ACCESSION NBR:8502050169 DOC.DATE: 85/01/30 NOTARIZED: NO DOCKET #  
 FACIL:50-261 H. B. Robinson Plant, Unit 2, Carolina Power and Light 05000261  
 AUTH.NAME AUTHOR AFFILIATION  
 CUTTER,A.B. Carolina Power & Light Co.  
 RECIP.NAME RECIPIENT AFFILIATION  
 VARGA,S.A. Operating Reactors Branch 1

SUBJECT: Forwards Part II response to request for addl info re  
 NUREG-0612, "Control of Heavy Loads at Nuclear Power  
 Plants," per Generic Ltr 81-07.Rept also addresses Generic  
 Ltr 83-42 re single failure proof cranes.

H. B. ROBINSON STEAM ELECTRIC PLANT, UNIT NO. 2  
DOCKET NO. 50-261/LICENSE NO. DPR-23  
CONTROL OF HEAVY LOADS

FIGURE  
3.7.2 - 6

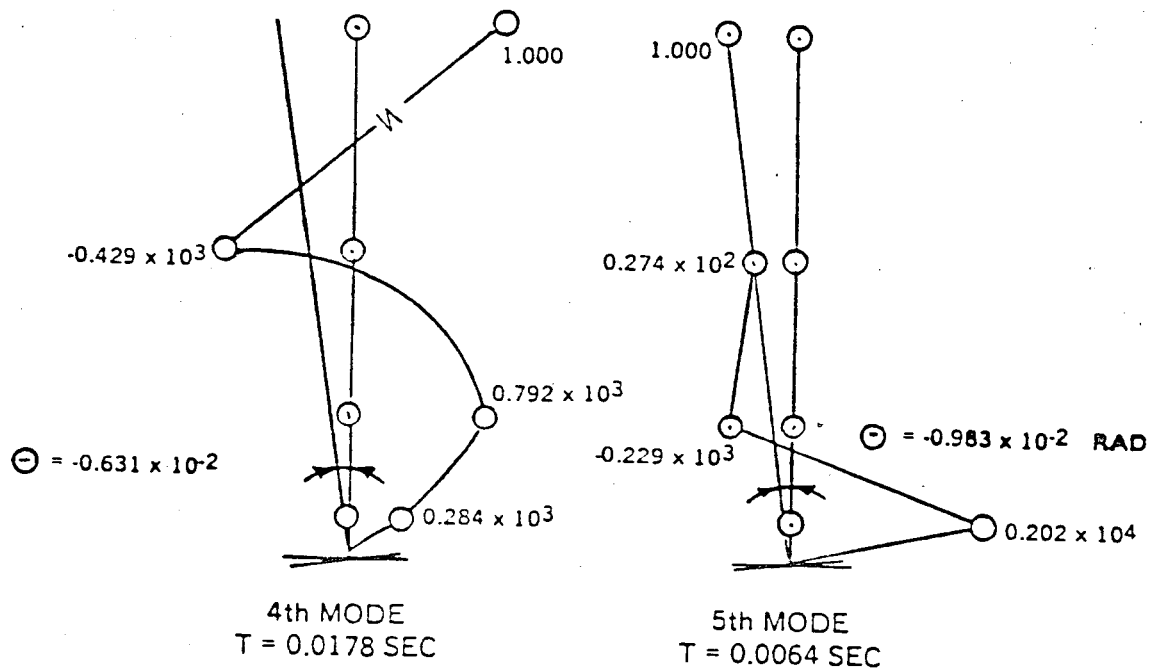
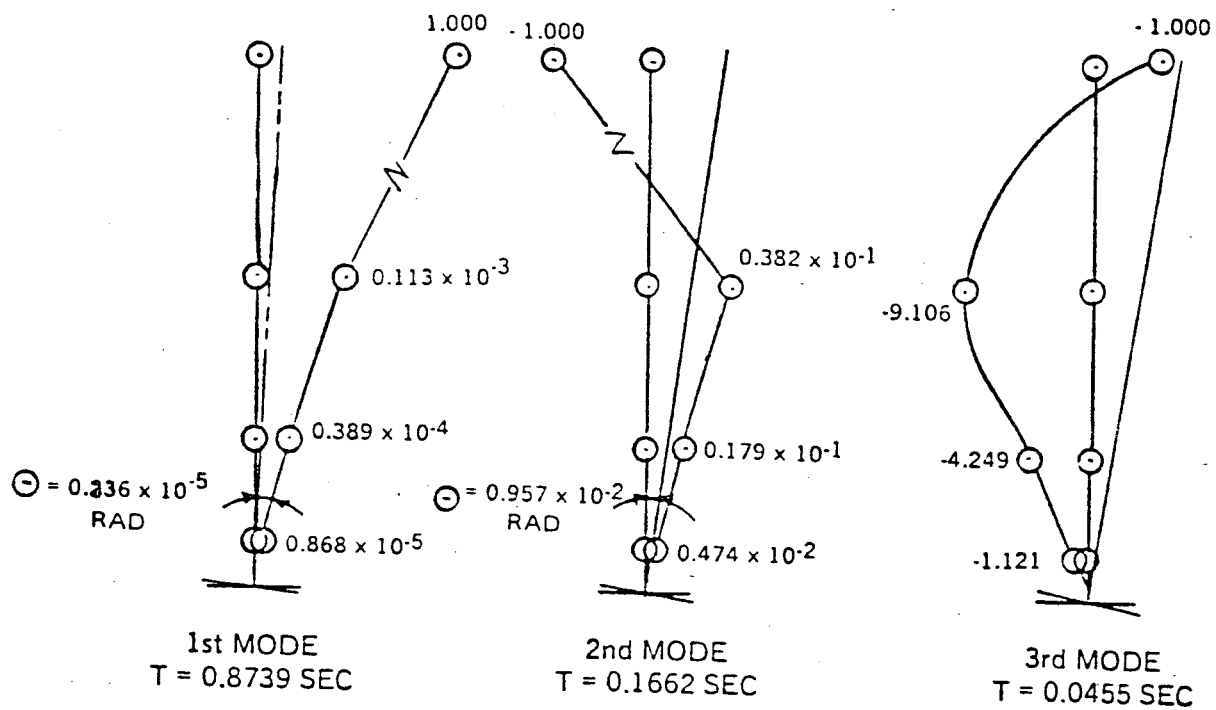
Item 3 - "With respect to the seismic analysis employed to demonstrate that the overhead handling system can retain the load during a seismic event equal to a safe shutdown earthquake, provide a description of the method of analysis, the assumptions used, and the mathematical model evaluated in the analysis. The description of assumptions should include the basis for selection of trolley and load position."

The containment crane was analyzed as a single mass coupled to the multi-mass model of the reactor containment inner structure which serves as its support. The first five mode shapes and the associated periods of vibration were computed utilizing stiffness matrix techniques. The response of each mode of vibration was computed utilizing the methods of modal analysis for the operational response spectra 0.1g and 0.2g design response spectra. Design values of total response were obtained by combining the individual model contributions on a root-mean square basis. The model used in design is shown in Figures 3.7.2-5 and 3.7.2-6.

CP&L considers the seismic design of the polar crane to be adequate.
